Product / ⊠ Major change □ Minor change	, ,					
PCN #:	PCN_WCAP-ASLL_20220421	Change Category:				
Affected Series:	WCAP-ASLL	 □ Equipment / Location ⊠ General Data □ Material 				
PCN Date:	January 21, 2022					
Effective Date:	April 21, 2022	 Product Design Shipping / Packaging Supplier Software 				
Contact:	Product Management	Data Sheet Change:				
Phone:	+49 (0) 7942 - 945 5001	🖂 Yes 🗆 No				
Fax:	+49 (0) 7942 - 945 5179	Attachment:				
E-Mail:	pcn.eisos@we-online.com	□ Yes ⊠ No

Because of a database mismatch, Würth Elektronik will update all datasheets for the Matchcode WCAP-ASLL.

Datasheet Update

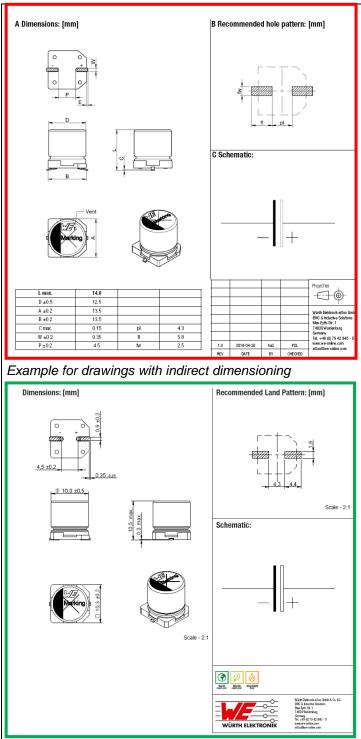
Würth Elektronik will update the datasheet layout in general for all WCAP-ASLL datasheets. Furthermore with this layout update Würth Elektronik will correct the electrical and mechanical characteristics. All corrections in terms of electrical characteristics are shown below. They will also be clearly visible in the new datasheets which Würth Elektronik will provide on the website shortly.

All corrections in terms of mechanical characteristics are shown. In order to visualize the corrections of the dimensions example of the old and the new drawings is shown below. Würth Elektronik will update the dimensioning from an indirect dimensioning to a direct dimensioning: Würth Elektronik eiSos GmbH & Co. KG EMC & Inductive Solutions
